# **Errata Sheet**

V1.1, 2005-09-23

Device C164SV-2R

Marking/Step Step (E)ES-AA, AA

Figure 1 Additional Jitter

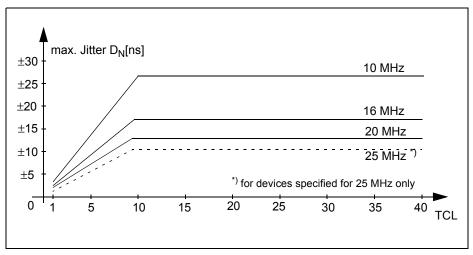
In systems were the PLL is used for generation of the CPU clock frequency, the PLL jitter can increase in certain circumstances and exceed the specified value.

The value of the additional jitter is not a fixed one but it depends on the kind of activity on the external bus or output pins. The additional jitter increases with the number of output/bus pins which are switched at the same time to a new voltage level because the problem is caused by noise on the on-chip power supply.

The additional jitter has the maximum effect if only one TCL is considered (period jitter). This can have an influence to the bus timings with one TCL.

The additional jitter decreases with the number of consecutive TCLs (accumulated jitter). The accumulated jitter has an effect on timings with more than one TCL (certain bus timings, CAN bus timing, serial interface).

For an accumulated period of N\*TCL the new maximum jitter  $D_N[ns]$ , which exceeds the specified value in the Data Sheet, is computed using the formula:

$$D_N[ns] = \pm (266 / f_{CPU}) * N / T_m$$

Were N = number of consecutive TCL,  $f_{CPU}$  = CPU frequency in MHz and  $T_m$  = 11.3 -  $f_{CPU}$  \* 0.13. This approximated formula is valid for a CPU frequency 10 MHz  $\leq f_{CPU} \leq$  20 MHz with the conditions:

$$T_m = 11.3 - f_{CPU} * 0.13$$
 for  $N \le T_m$   
 $T_m = N$  for  $N > T_m$

The accumulated jitter is in the specified range for accumulated periodes longer than N = 40 TCL.

In the case that the additional jitter causes problems in the system which cannot be relaxed with software adapted timing parameters the following workarounds are possible:

- If the clock generation is done with the on-chip oscillator then direct drive- or prescaler mode can be used.
- If the maximum frequency of the on-chip oscillator in not sufficient then an external clock generator can be used.

Figure 2 SSCTB Timing

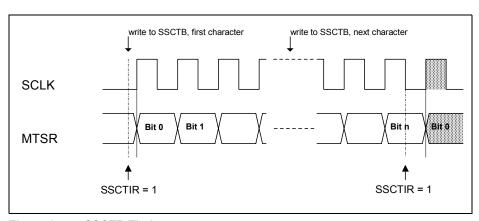
In master mode, the timing of SSCTIR is as follows:

When SSCTB has been written while the transmit shift register was empty (and the SSC is enabled), flag SSCTIR is set to '1' directly after completion of the write operation, independent of the selected baud rate. When the transmit shift register is not empty when SSCTB was written, SSCTIR is set to '1' after the last latching edge of SCLK (= 1/2 bit time before the first shifting edge of the next character). See also e.g. C167CR User's Manual V3.1, p. 12-5.

The following diagram shows these relations in an example for a data transfer in master mode with SSCPO = 0 and SSCPH = 0. It is assumed that the transmit shift register is empty at the time the first character is written to SSCTB:

Typically, in interrupt driven systems, no problems are expected from the modified timing of flag SSCTIR. However, when flag SSCTIR is polled by software in combination with other flags which are set/cleared at the end or at the beginning of a transfer (e.g. SSCBSY), the modified timing may have an effect.

Another situation where a different system behaviour may be noticed is the case when only one character is transferred by the PEC into the transmit buffer register SSCTB. In this case, 2 interrupt requests from SSCTIR are expected: the 'PEC COUNT = 0' interrupt, and the 'SSCTB empty' interrupt:

When the PEC transfer is performed with sufficient margin to the next clock tick from the SSC baud rate generator, and no higher priority interrupt request has occurred in the meantime, the 'PEC COUNT = 0' interrupt will be acknowledged before the 'SSCTB empty' interrupt request is generated, i.e. two interrupts will occur based on these events. However, when the PEC transfer takes place relatively close before the next clock tick from the SSC baud rate generator, or a higher priority interrupt request has occurred while the PEC transfer is performed, the 'PEC COUNT = 0' interrupt may not be acknowledged before the 'SSCTB empty' interrupt request is generated, such that effectively only one interrupt request will be generated for two different events.

In order to achieve a defined and systematic behavior with all device steps, the SSC receive interrupt, which is generated at the end of a character transmission, may be used instead of the SSC transmit interrupt.
